## PIC16C63 Rev. A Silicon Errata Sheet

The PIC16C63 (Rev. A) parts you have received conform functionally to the Device Data Sheet (DS30234D), except for the anomalies described below.

## Clarifications/Corrections to the Data Sheet:

**FIGURE 1: SCK PULSE VARIATION USING TIMER2/2**

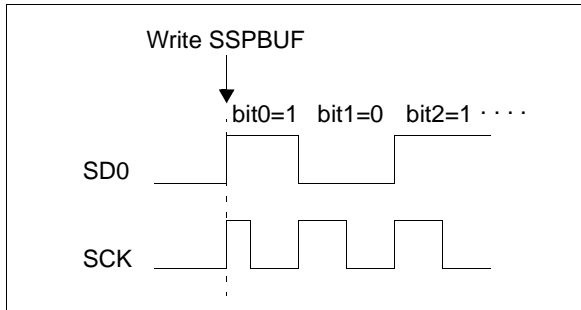
When the SPI is using Timer2/2 as the clock source, a shorter than expected SCK pulse may occur on the first bit of the transmitted/received data (Figure 1).

To avoid producing the short pulse, turn off Timer2 and clear the TMR2 register, load the SSPBUF with the data to transmit, and then turn Timer2 back on. Refer to Example 1 for sample code.

**FIGURE 1: WRITES TO TIMER1 (EXTERNAL CLOCK/OSCILLATOR MODE)**

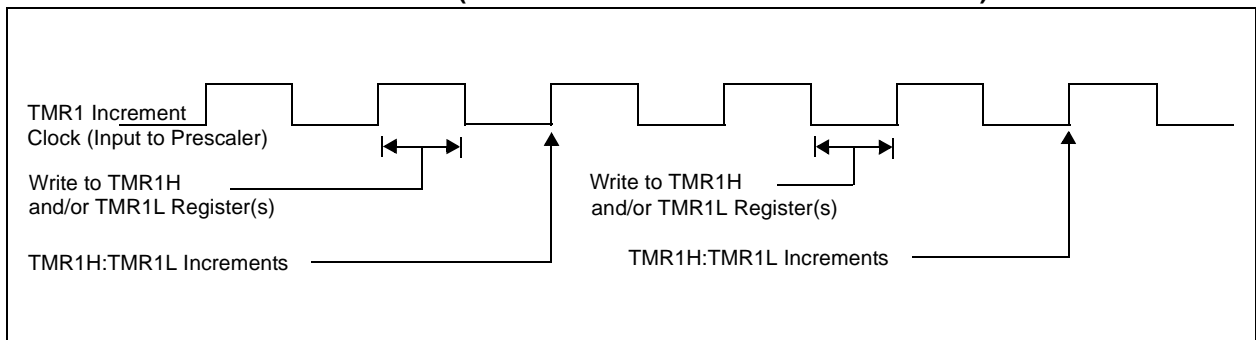
The operation of Timer1 needs some clarification when the timer registers are written when the TMR1ON bit is set.

The internal clock signal that is the input to the TMR1 prescaler affects the incrementing of Timer1 (TMR1H:TMR1L registers and the Timer1 prescaler). When the Timer1 registers are NOT written, the Timer1 will increment on the rising edge of the TMR1 increment clock.

When the TMR1H and/or TMR1L registers are written while this clock is high, TMR1 will increment on the next rising edge of this clock.

When the TMR1H and/or TMR1L registers are written while this clock is low, TMR1 will not increment on the next rising edge of this clock, but must first have a falling clock and the rising clock for TMR1 to increment.

Figure 1 shows the two cases of writes to the TMR1H and/or TMR1L registers. Due to the  $V_{IH}$  and  $V_{IL}$  thresholds on the oscillator/clock pins, external Timer1 oscillator components, and external clock frequency, the Timer1 increment clock may not be of a 50% duty cycle.

The TMR1 increment clock is out of phase of the T1OSO/T1CKI pin by a small propagation delay.
